San Jacinto River Waste Pits Superfund Site

Comments
of
International Paper Company
and
McGinnes Industrial Maintenance Corporation
on
U.S. Environmental Protection Agency Region
6
Proposed Remedial Action Plan

January 12, 2017

Figure 9:
1992 and 1995 Aerial Photographs with Shoreline Extents
IP/MIMC January 12, 2017 Comments to Proposed Plan

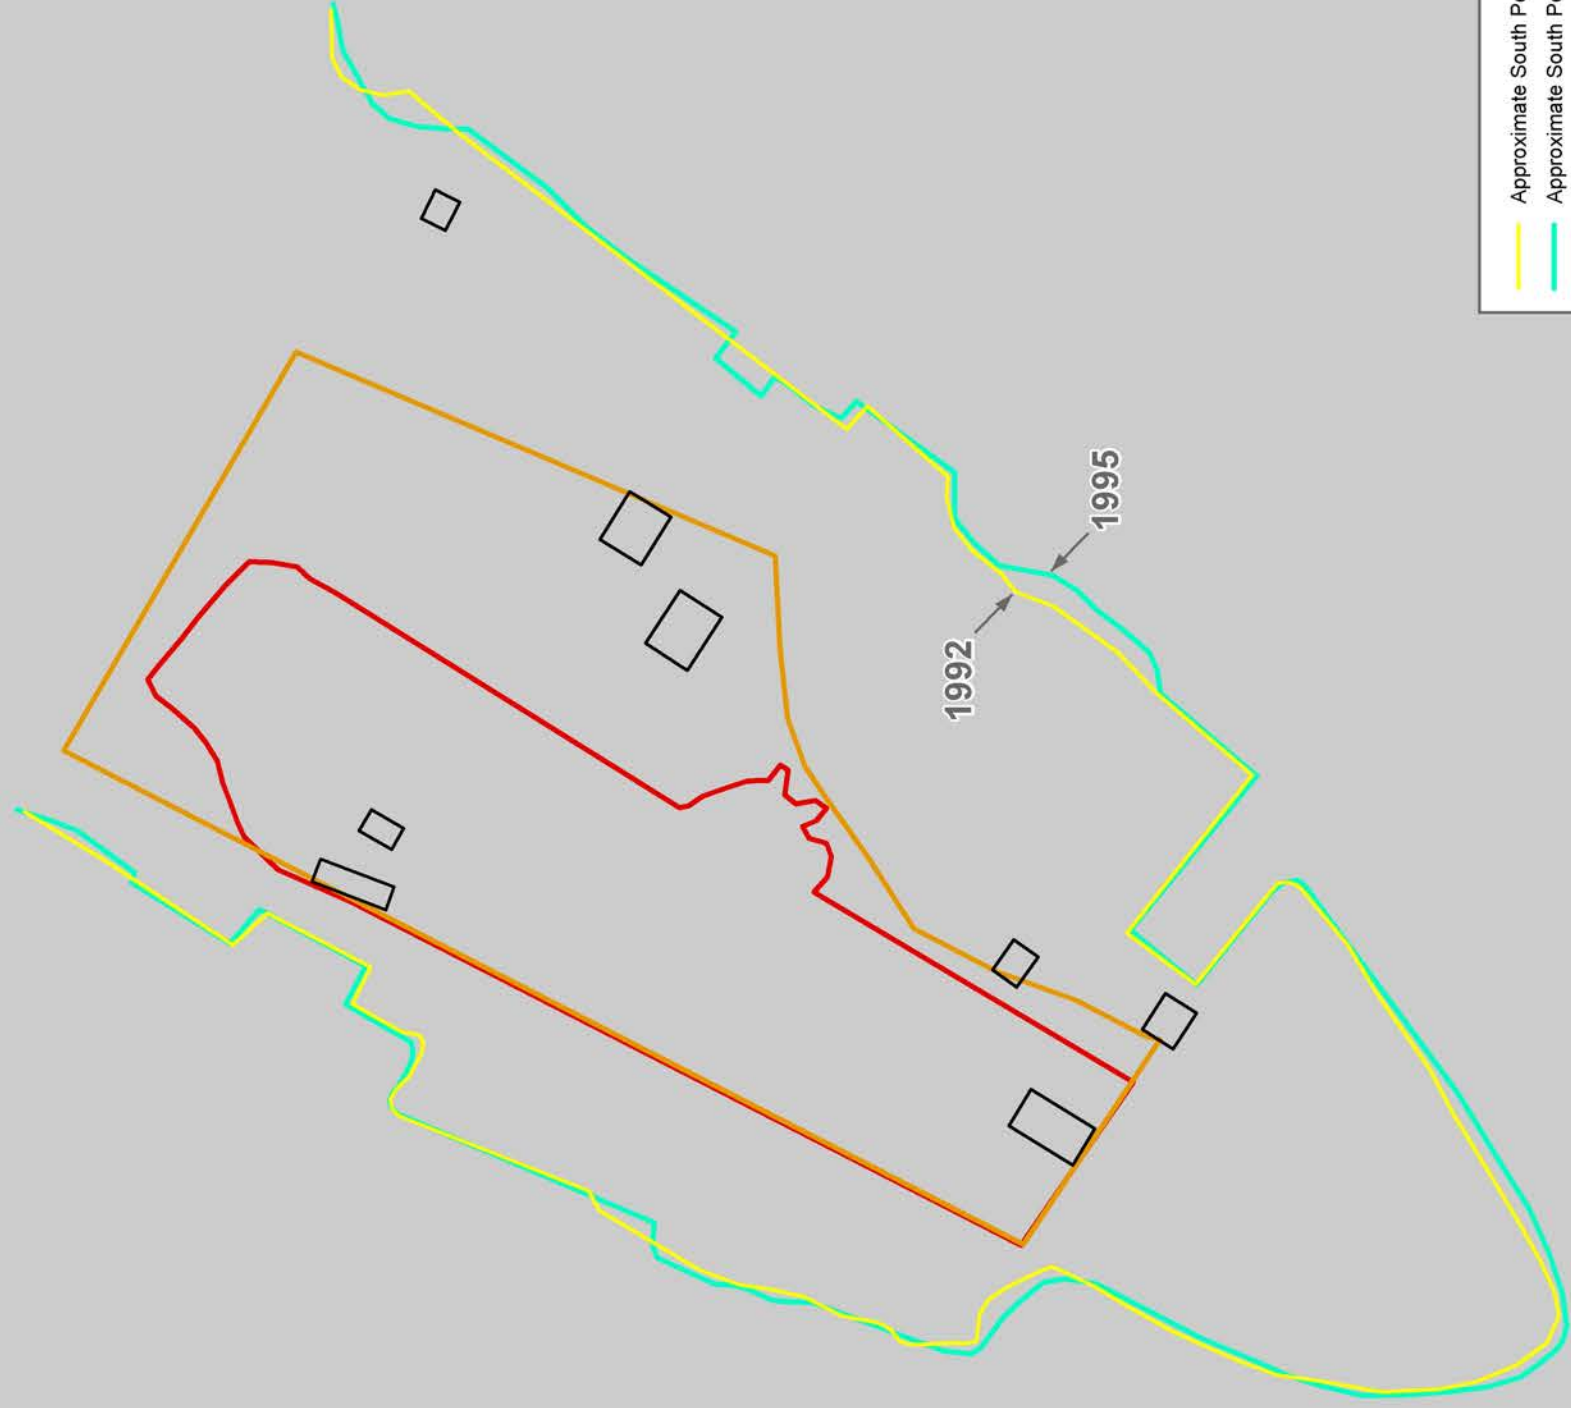
The RI of the area south of I-10, conducted by International Paper,⁴⁰⁶ identified paper mill waste (along with a variety of unrelated wastes) disposed of in an area in the northwest portion of the peninsula, as shown on Figure 9. This area is west

flood of 1994. For example, several buildings, roads and other structures present across the peninsula south of I-10 in the 1992 and 1994 photographs were also present in 1995 (Figure 9). The historical photographic record for the peninsula south of I-10 shows the perimeter of the peninsula and other characteristics of this area to have been stable in the 1994 flood.

Figure 10:
Figure 6-8 from RI Report - Distribution of TEQ_{DFM}
In and Adjacent to the Area of Investigation South of I-10
IP/MIMC January 12, 2017 Comments to Proposed Plan

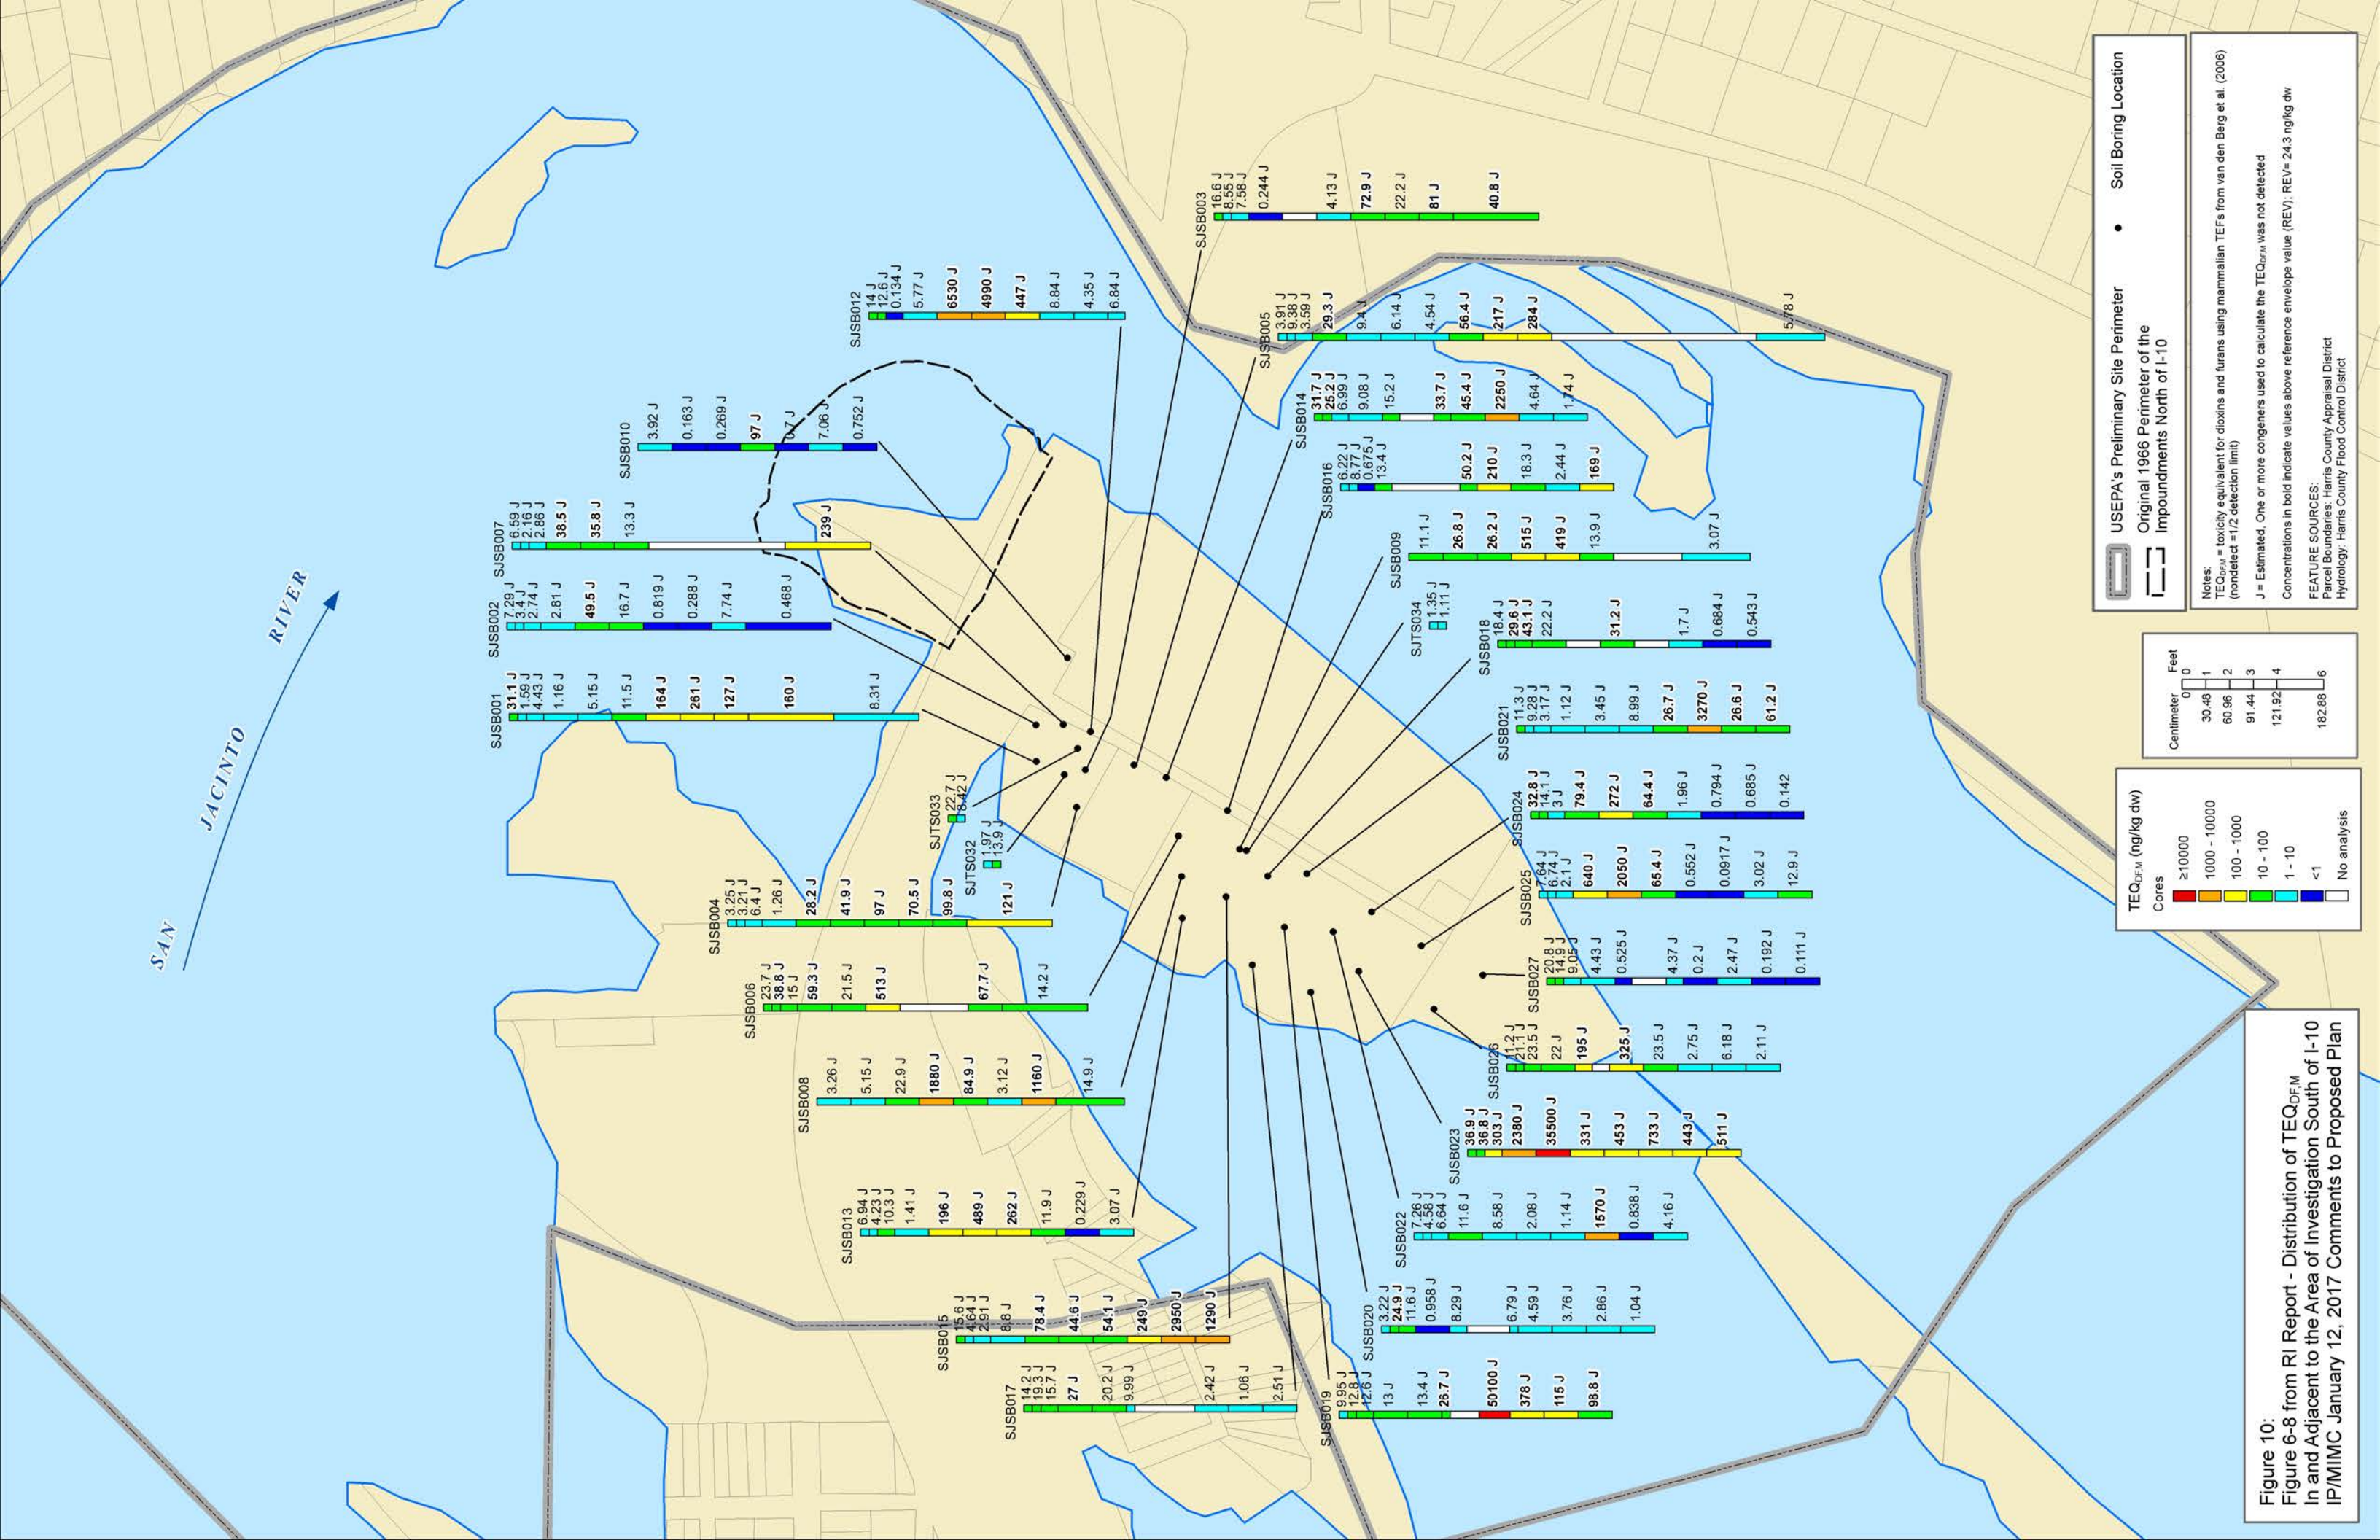
- Soil Sampling. Soil sampling conducted in 2011 and 2012 identified locations in which paper mill wastes containing dioxins and furans were located together with material originating from other sources. Dioxins and furans associated with paper mill waste were located at depth, ranging from one foot but mostly four to five feet bgs, as shown on Figure 10. Depth weighted TEQ concentrations in the top two feet of soil are below Region 6's soil protective level of 51 ng/kg (Figure 10) in all but one location. Depth-weighted TEQ concentrations in the top two feet of soil are below regional background TEQ surface soil concentrations in 24 of the 26 core samples for the RI (Figure 10)⁴¹⁹.
